MICROLIGHT AIRWORTHINESS APPROVAL NOTE

MAAN NO: 1661

TITLE: Microlight Airworthiness Approval Note 1661, ASI and altimeter corrections on Shadow Series C and CD aircraft.

BMAA Service Bulletin 1661

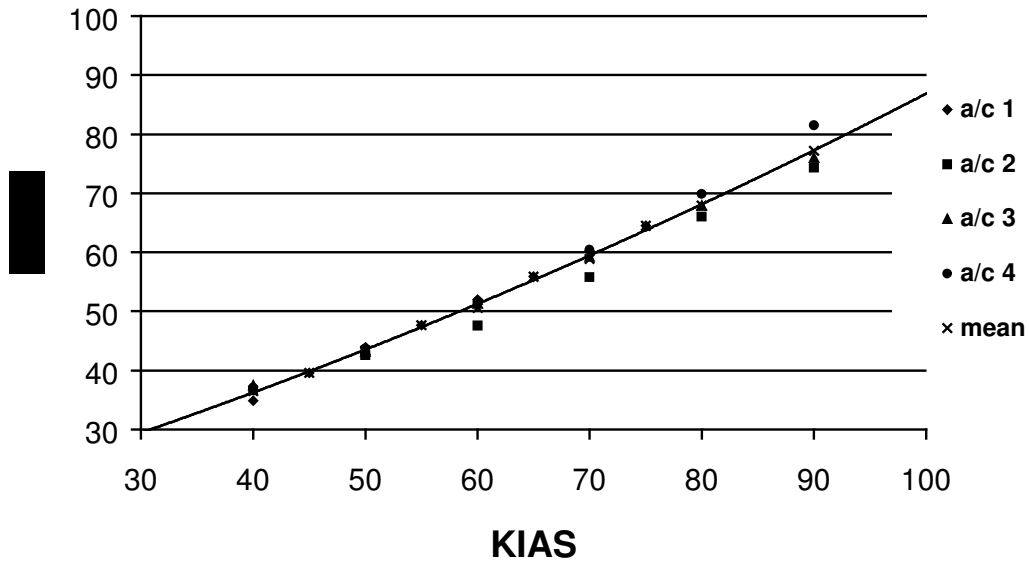
Four Shadow CD aircraft have been flown to establish the errors in the static system. In each case, the aircraft were flown using the ASI calibration method as set out in BMAA TIL027. This involves a 'racetrack' pattern being flown, recording ASI readings against GPS readings upwind and downwind.

The four sets of flight test data show good correlation, enabling a speed correction table to be produced with high confidence. This is shown in the attached Service Bulletin.
